GNRO-2016/00024

SUBJECT: Operating License Manual Update Submittal  
Grand Gulf Nuclear Station, Unit 1  
Docket No. 50-416  
License No. NPF-29

Pursuant to 10 CFR 50.71(e), Entergy Operations Inc. hereby submits an update of all changes made to the Grand Gulf Nuclear Station Operating License Manual (Technical Specification Bases, Technical Requirement Manual, and Offsite Dose Calculation Manual, since the last submittals (References 1 and 2 above). The Pressure Temperature Limits Report) was last submitted under Reference 3 as a proprietary document and is being resubmitted in accordance with the requirements of 10 CFR 50.71(e).

**Attachment 1**  
**GNRO-2016/00024**  
**Change Summary**

Figure 3.0-1  
Collection Site Locations, 0-4 Mile Area Map

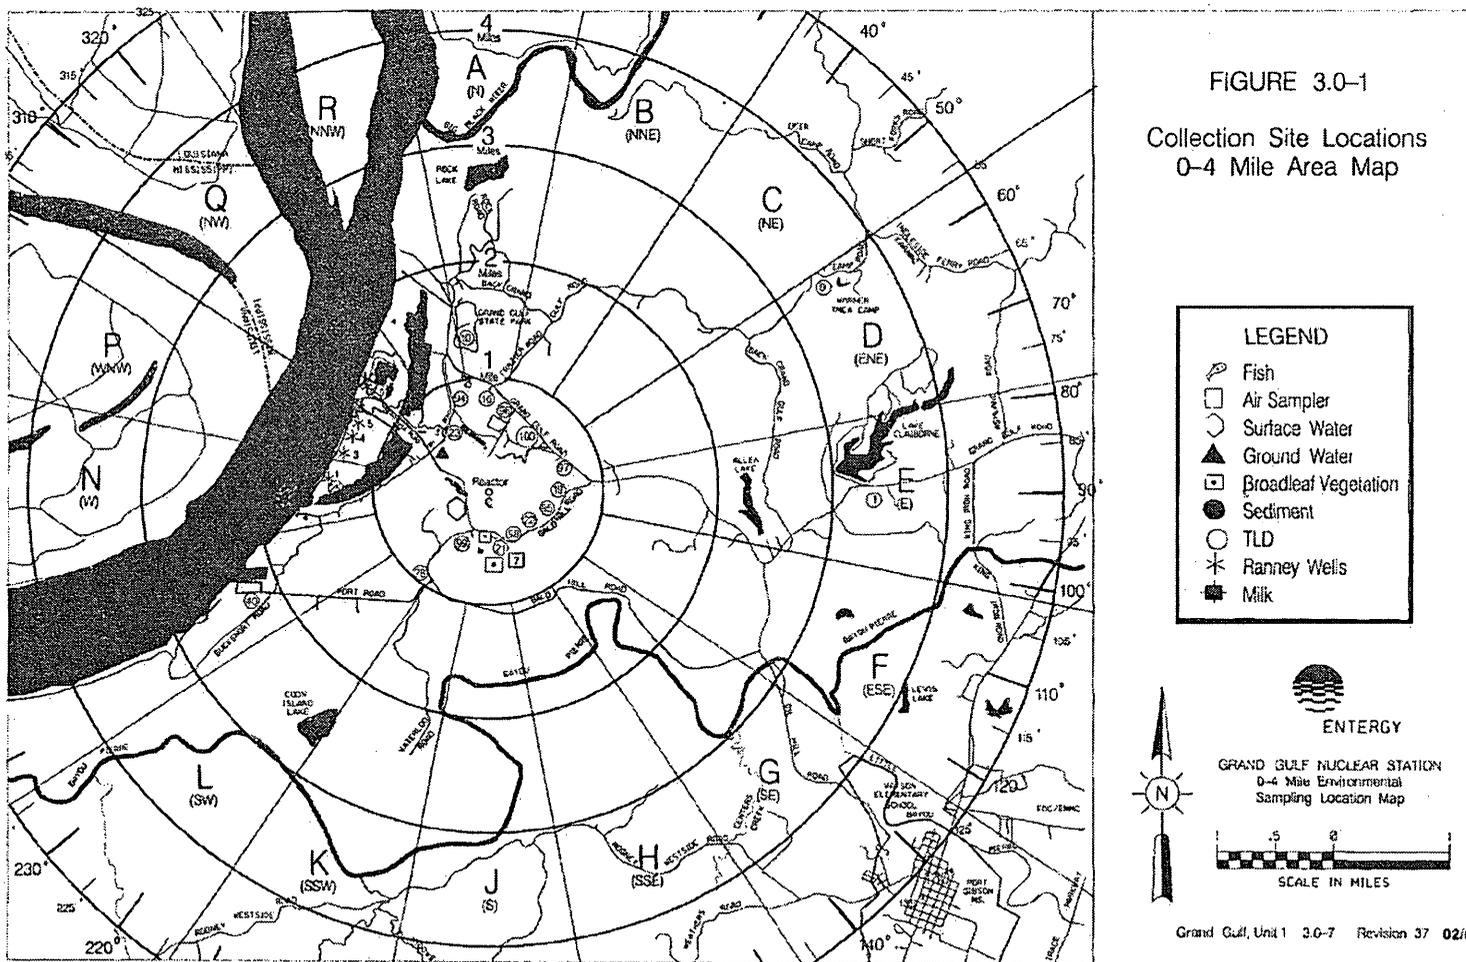
<b>LBDCR Number</b>	<b>Topic of Change</b>	<b>Affected Technical Specification Bases Pages</b>
2011-0002	Placement of Radial Well into Service	ODCM Figure 3.0-1
2011-0026	EPU Main Steam Line High Flow Isolation Setpoint Change	TRM Page 3.3-58 – II
2013-0009	Fire Protection TRM requirements updated for 24 month fuel cycle	TRM Pages 6.2-2, 6.2-23, 6.2-25, 6.2-27, and 6.2-34
2013-0024	Addition of ODCM 6.3.9 Condition E and applicable C and Change Condition D to be only applicable to Condition B	ODCM Page A-14
2014-0026	Technical Specification Bases and UFSAR update to remove Division I and II high vibration trips and alarms	TS Bases Pages B3.8-25,
2014-0027	First Stage Turbine Pressure Instrument Sensing Line Failure Multiple Times Requiring Temporary Modification	TRM Pages 3.3-8 – II, 3.3-18 – II, and 3.3-28 – I  TS Bases Pages B3.3-15, B3.3-17, B3.3-28, B3.3-40, B3.3-41, B3.3-46, B3.3-68, B3.3-69a, B3.3-70, and B3.3-71
